PCN (Product Change Notice)							
<input checked="" type="checkbox"/> Major Change <input type="checkbox"/> Minor Change							
PCN Number: PCN_WPME-FDSM_20250523 Affected Series: WPME-FDSM Affected Part Number: 173950536 PCN Date: 2025-05-23 (YYYY-MM-DD) Effective Date: Effective Immediately	Change Category: <input checked="" type="checkbox"/> Equipment/Location <input checked="" type="checkbox"/> General Data <input checked="" type="checkbox"/> Material <input type="checkbox"/> Process <input checked="" type="checkbox"/> Product Design <input checked="" type="checkbox"/> Shipping/Packaging <input checked="" type="checkbox"/> Supplier <input type="checkbox"/> Software						
Contact: Product Management Phone: +49 (0) 7942 - 945 5001 Fax: +49 (0) 7942 - 945 5179 E-Mail: pcn.eisos@we-online.com	Datasheet Change: <input checked="" type="checkbox"/> Yes <input type="checkbox"/> No Attachment: <input type="checkbox"/> Yes <input checked="" type="checkbox"/> No						
DESCRIPTION OF CHANGE: <p>Due to an urgent case of component availability, this PCN has an accelerated PCN and effective date.</p> <p>Due to an improvement of the production capability, Würth Elektronik eiSos has shifted th

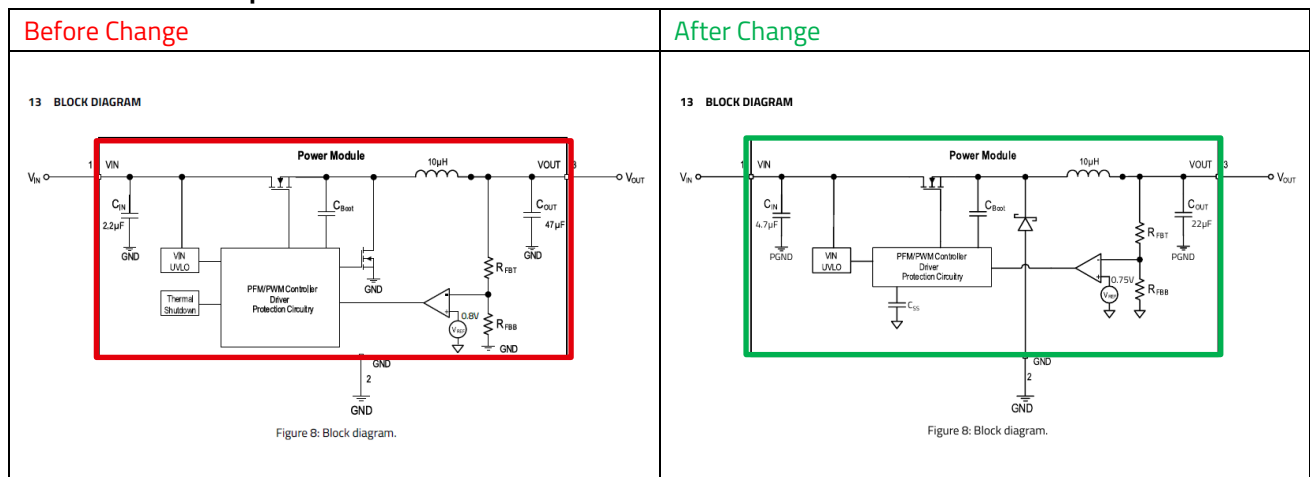
The diagrams shown in the TYPICAL PERFORMANCE CURVES chapter are updated based on the new internal BoM and integrated IC change. The used test conditions remain the same as before.

Due to the change of the integrated IC, the internal BoM has changed. The new components are shown in the BLOCK DIAGRAM chapter.

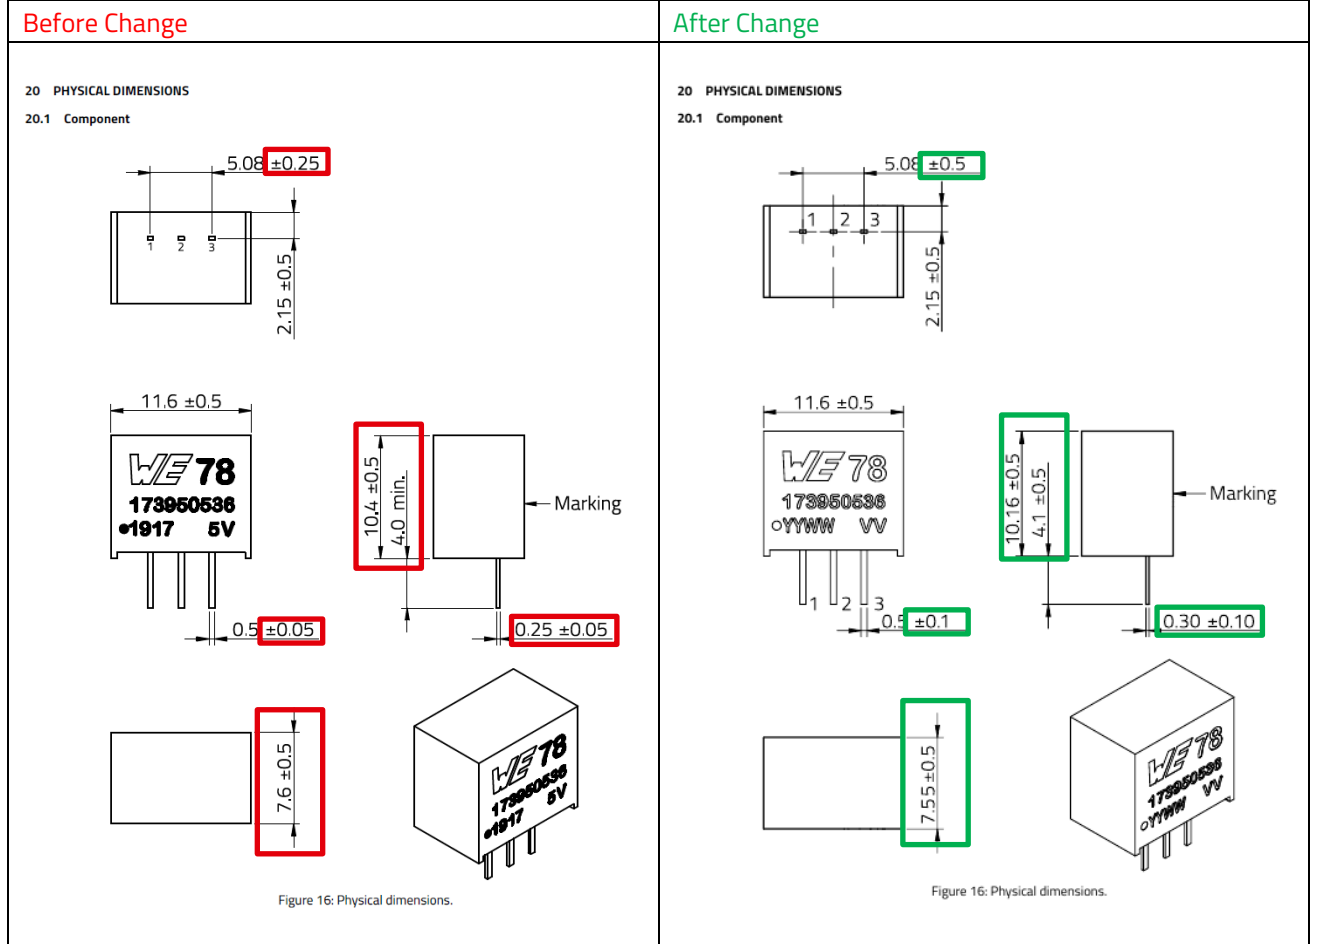
The diagrams shown in the PROTECTION FEATURES chapter are updated based on the new internal BoM and integrated IC change. The used test conditions remain the same as before.

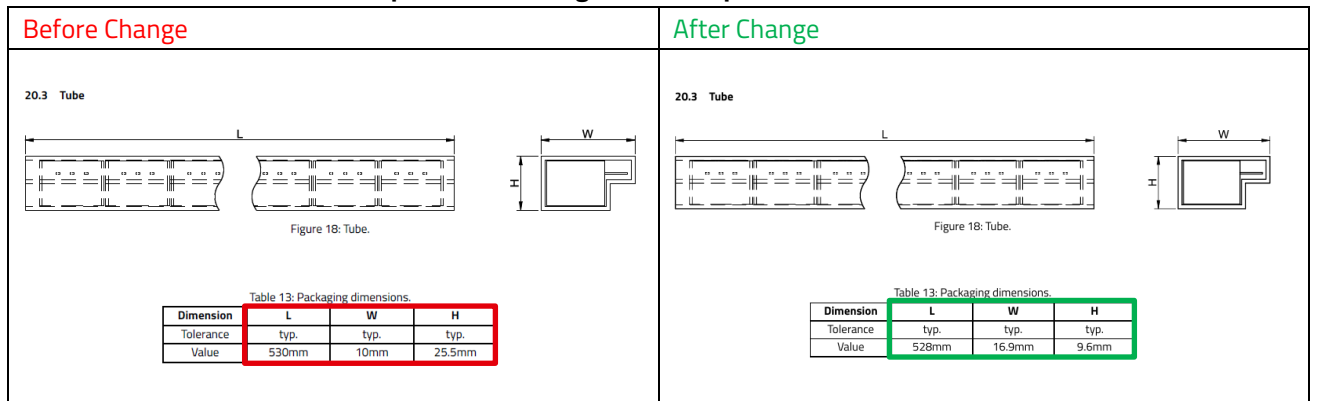
The mechanical dimensions have been updated based on the new production. The device dimensions and tolerances have been updated. The SIP-3 land pattern will remain the same.
